Memo

Planning Application Ref: PL/25/1272

Address: West Chazey, Upper Warren Avenue, Caversham, Reading, RG4 7ED

Proposal: Proposed new pool house

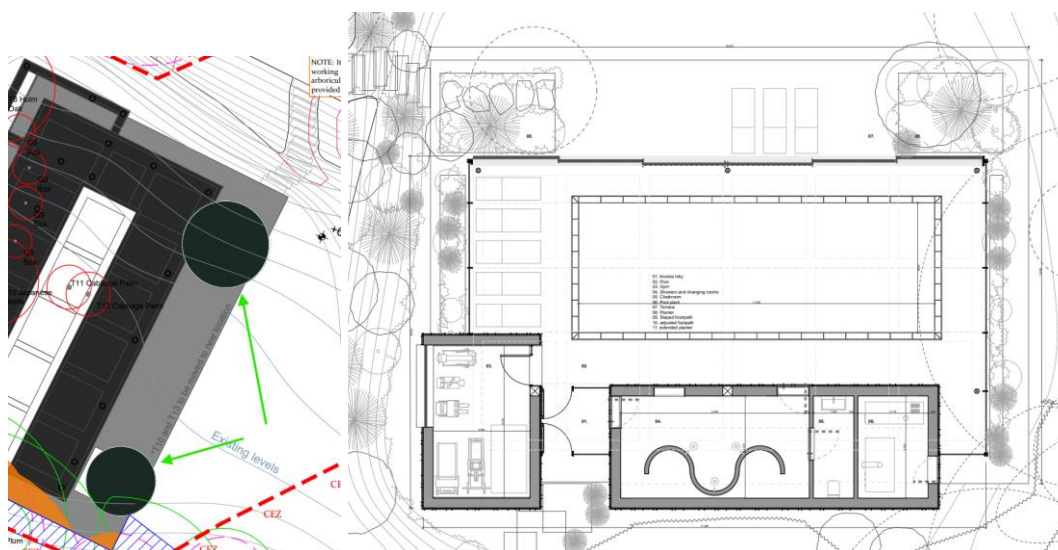
With reference to the Tree Protection Plan (TPP), 25th August, Drawing No. TH/A3/5288/TPP, I note the relocated positions of T10 and T13 (shown by green arrows below) appear to be in a hard surfaced area (although difficult to determine due to lack of labels). With reference to the Proposed Ground Floor Plan, 9th July 2023, Drawing No. 03, I note this includes a planting bed within the landscaped area surrounding the pool house, where the trees will be relocated. It is certainly positive that relocating T10 and T13 has been suggested and incorporated into the landscape design. However, I am wary that it may be more feasible and successful to replant new trees, which would be acceptable to us as an alternative, but it's at the applicant's discretion.
